Agenda Item	6.1
Report No	PLS-52-24

HIGHLAND COUNCIL

Committee: South Planning Applications Committee
Date: 01 October 2024
Report Title: 23/05579/S36: Fred Olsen Renewables Limited
Culachy Estate, Land 4km SE of Newtown, Invergarry
Report By: Area Planning Manager – South

Description: Culachy Wind Farm - Erection and operation of a wind farm comprising 8 wind turbines with a maximum blade tip height of 200m, battery energy storage system, site access junction, access tracks, crane hardstandings, underground cabling, on-site substation and maintenance building, temporary construction compounds, laydown areas, batching plant and potential excavation/borrow pits.

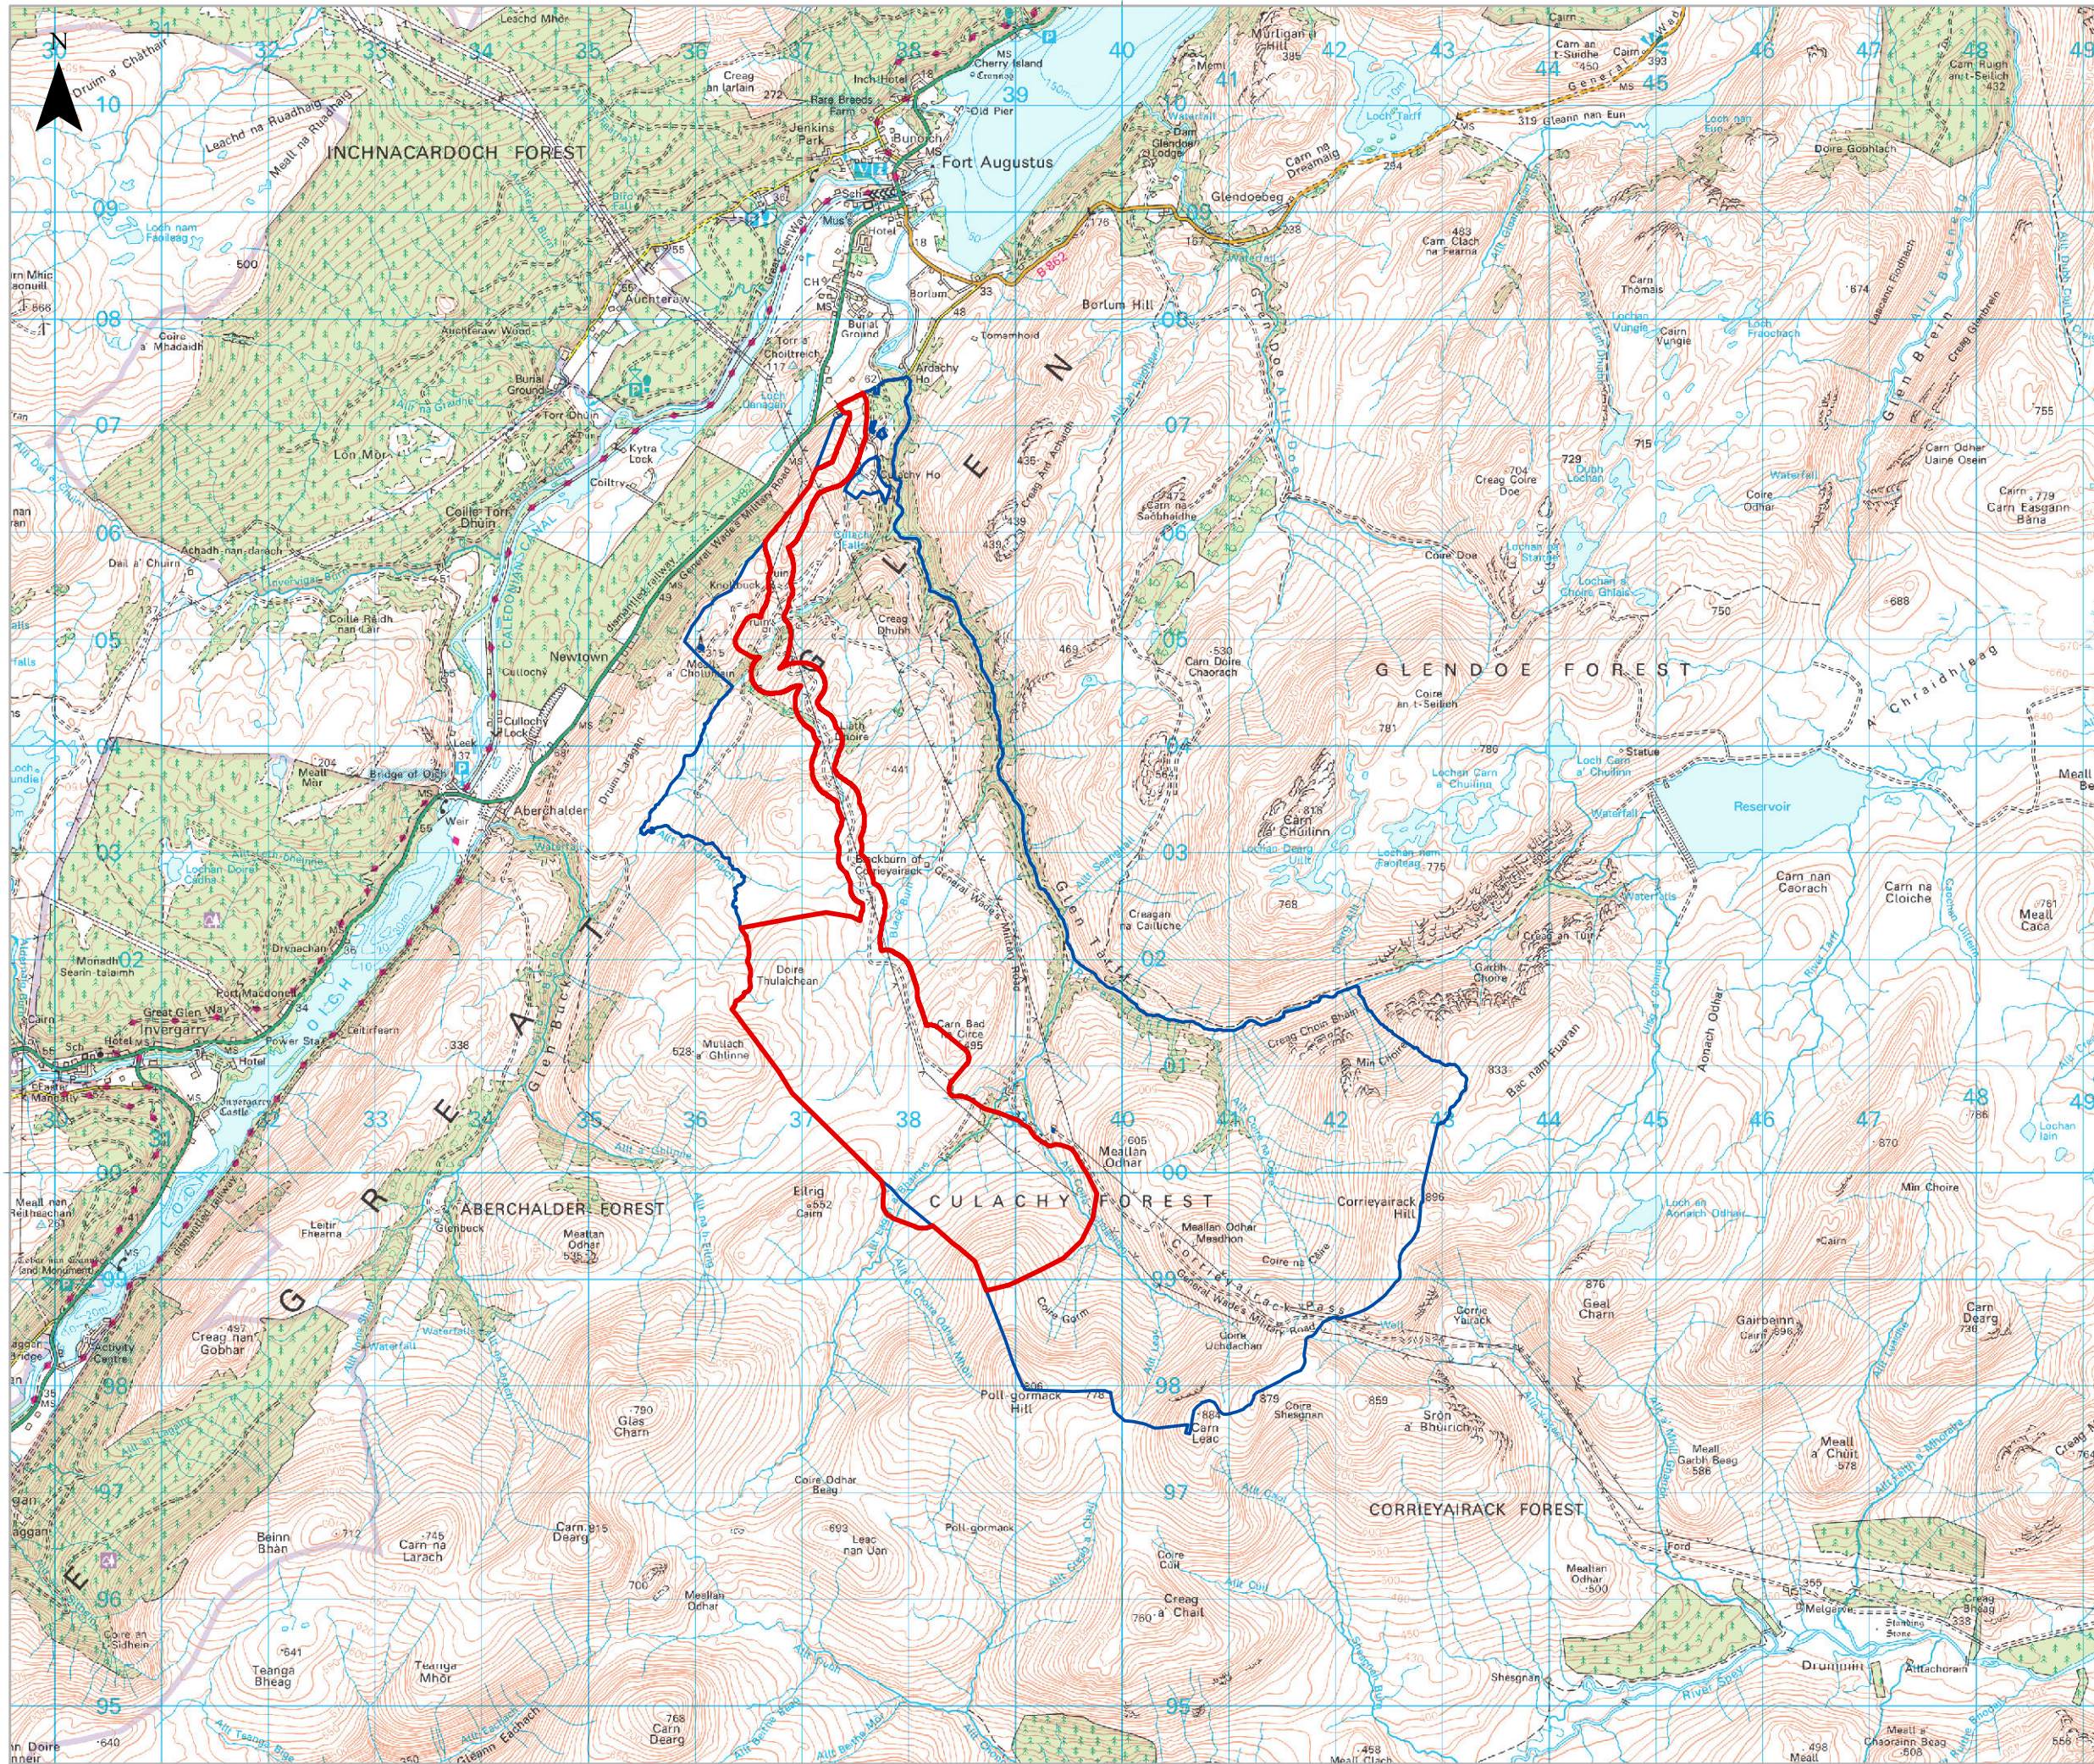
Viewpoint	App / THC	Sensitivity of the Receptor the Receptor (Susceptibility / value of the view) High, Medium, Low	Proposed Development			Cumulative		
			Magnitude of change (Scale of Change / Extent / Duration) High, Medium, Low, Negligible	Level of Effect (Magnitude of change / Sensitivity of Receptor)	Significance (Major and Major- Moderate are Significant. Moderate may be significant)	Magnitude of Cumulative Change (Scale / Extent / Duration)	Level of Effect (Magnitude of Change / Sensitivity of Receptor)	Significance (Major and Major-Moderate are Significant. Moderate may be significant)
			<p>All turbines would be visible showing as blades, hubs and towers in view. Access tracks and hardstandings would be visible but are less perceptible given the distance from the viewpoint. The proposed development will result in the addition of wind turbines in the iconic upland landscape that lies beyond and to the south of the Great Glen and the southern edges of Loch Ness. Whilst not immediately behind the view of Fort Augustus, the proposed development would appear in the same part of the panorama as this key focus of the view creating an additional emphasis on the upland beyond. Turbines appear as a linear array backclothed by the gently sloping landform in the background. T8 appears as an outlier slightly disconnected from the rest of the group. This panorama is currently free from wind energy development and the proposed development would increase the spread of wind turbines into an area that has previously been safeguarded to retain views south towards the Great Glen.</p> <p>The consented Bhlaraidh Extension will appear within close context to Bhlaraidh wind farm and appear to bring development closer and at a larger scale. Now consented Bunloinn would appear within the same part of the panorama as Beinneun and Extension in the view south extending development to the west with the proposed Tomchrasky appearing beyond and to the east of Bhlaraidh wind farm. These schemes would appear to narrow the gap between the Beinneun and Bhlaraidh wind farms. To the east, consented Aberarder will appear beyond Dunmaglass Estate wind farm development extending the operational development on the horizon. Now consented Corriegarth 2 would appear within close context and in the foreground of the Corriegarth wind farm in the view east. These turbines would appear larger in scale than the existing development and increase the horizontal extent currently occupied by Corriegarth wind farm with several turbines appearing above the horizon unlike the existing turbines. Now consented Cloiche would further expand Stronelairg and consented Dell with turbines extending on the horizon to the south east with the Cloiche turbines appearing larger and more visible than the Stronelairg turbines with many behind intervening landform. To the south east Dell will appear within the context of the Stronelairg wind farm but will be slightly more conspicuous above the horizon than the existing visible turbines. These developments further contribute to the increased awareness of wind energy development in multiple facets of the view. However, recent wind energy development has tried to consolidate existing clusters of turbines within the contained upland bowl landform whereas this proposed development is expanding into an area of respite free from turbines with the intention to protect views south towards the Great Glen. As such, it is considered that the cumulative impacts have been understated. The applicant considered there is a Medium-Low magnitude of change and Moderate level of effect leading to a</p>

Viewpoint	App / THC	Sensitivity of the Receptor the Receptor (Susceptibility / value of the view) High, Medium, Low	Proposed Development			Cumulative		
			Magnitude of change (Scale of Change / Extent / Duration) High, Medium, Low, Negligible	Level of Effect (Magnitude of change / Sensitivity of Receptor)	Significance (Major and Major-Moderate are Significant. Moderate may be significant)	Magnitude of Cumulative Change (Scale / Extent / Duration)	Level of Effect (Magnitude of Change / Sensitivity of Receptor)	Significance (Major and Major-Moderate are Significant. Moderate may be significant)
<p>conclusion that the cumulative impact of consented schemes was not significant. It is considered there is Medium-High magnitude of change and Major level of effect. Overall, this has led to a conclusion of Major impact on receptors. The cumulative effect is considered Significant.</p> <p>More broadly, the applicant considered there is a Medium-Low magnitude of change and Moderate level of effect. It is considered there is Medium-High magnitude of change and Major level of effect. Overall, this has led to a conclusion of Major impact on receptors. The effect is considered Significant.</p>
